United States Patent and Trademark Office

APPLICATION NO.	FILING DATE	FIRST NAMED INVENTOR	ATTORNEY DOCKET NO.	CONFIRMATION NO.
10/823,137 04/13/2004		Craig D. Quarberg	20040030.ORI	4527
23595 75	590 12/29/2005	EXAMINER		
NIKOLAI & MERSEREAU, P.A. 900 SECOND AVENUE SOUTH		LUGO, CARLOS		
SUITE 820			ART UNIT	PAPER NUMBER
MINNEAPOLI	S, MN 55402	3676

DETAILED ACTION

Attachment #1

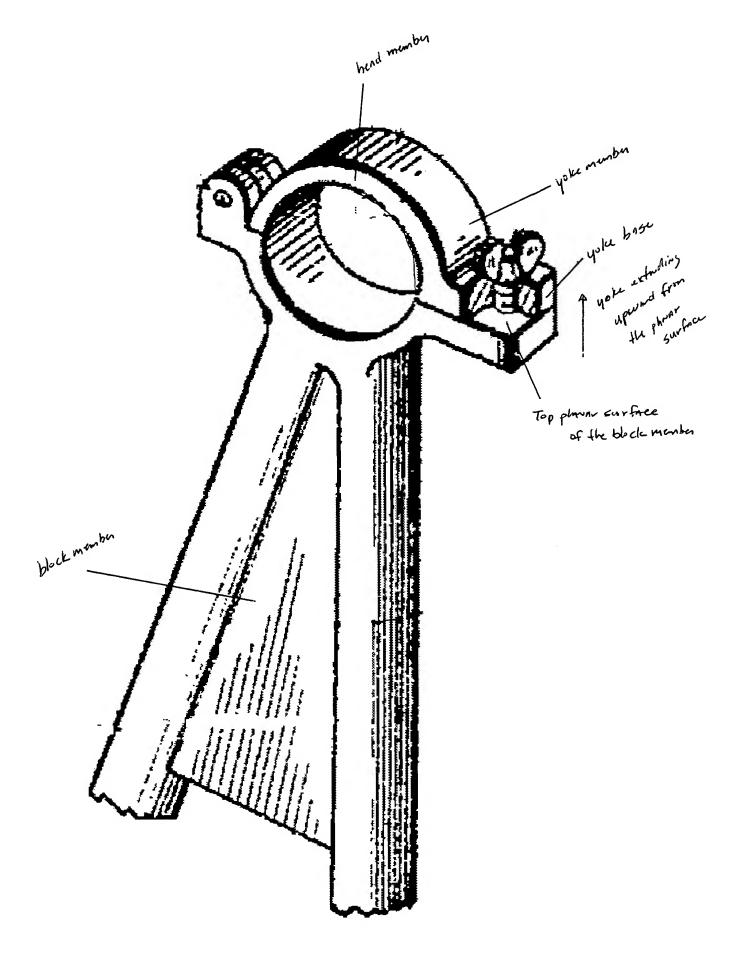
Regarding claims 1,3 and 4, Shyer discloses a security brace comprising a plurality of pole members including upper and lower ends (6 and 8); and a block member (10) at the upper end of the pole members and having a top planar surface with a yoke member extending upwardly from the top planar surface (see attachment #1).

The yoke member includes a yoke base and a head member sloping at a predetermined angle to a longitudinal axis of the yoke base (at any convenient point, see attachment #1).

The applicant argues that the yoke member described by Shyer does not extend upwardly from the top planar surface of the block member (Page 8 Line 11). As seen in attachment #1, Shyer clearly illustrates that the yoke member extends upwardly from the top planar surface. Therefore, the argument is not persuasive.

First, the applicant fails to illustrate the "longitudinal axis". Second, Shyer illustrates that the head portion of the yoke slopes at a "predetermined angle" with respect to a longitudinal axis (at any convenient point). Therefore, the argument is not persuasive.
